Amendment C296Case: Croskell Employment PSP
Melbourne Water Submission - 16 October 2024

Item No.	Document	Reference	Topic	MW Submission to Agency Validation
1	PSP	General	DSS	MW's DSS is still being refined and subject to change for Public Exhibition which will result in changes to the Place Based Plan. This includes a potential crossing of the VDP cable in the eastern catchment.
2	PSP	General	Mapping	Drainage asset not shown on plans. Proposed sediment basin to be added on plans. MW to supply spatial data. 
3	PSP	General	Further considerations	MW is further investigating groundwater risks associated in this catchment. Impact of groundwater may change asset location and increase sizes if assets are to be shallower to reduce groundwater interaction. More detailed groundwater assessment will impact the PSP time frame.

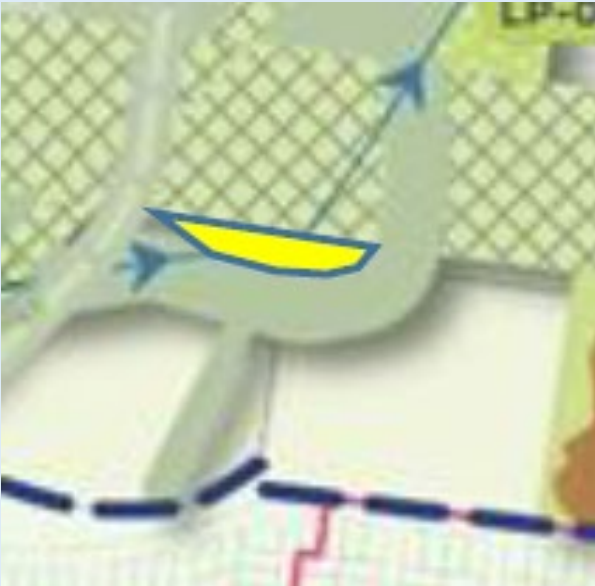
15	PSP	Plan 4	Mapping	Change label of “Underground waterpipe” to Proposed underground drainage pipe
15	PSP			Change label symbol of “main water supply pipeline” - Symbol for this feature should be clearer on the plan.
16	PSP	Table 9, 3.4.O3	Addition / amendmen t	Add following objective: To ensure stormwater is managed for flood protection factoring in climate change, water quality treatment, to ensure stormwater drainage is managed to meet critical infrastructure crossing requirements, consistent with the Development Services Scheme (DSS).
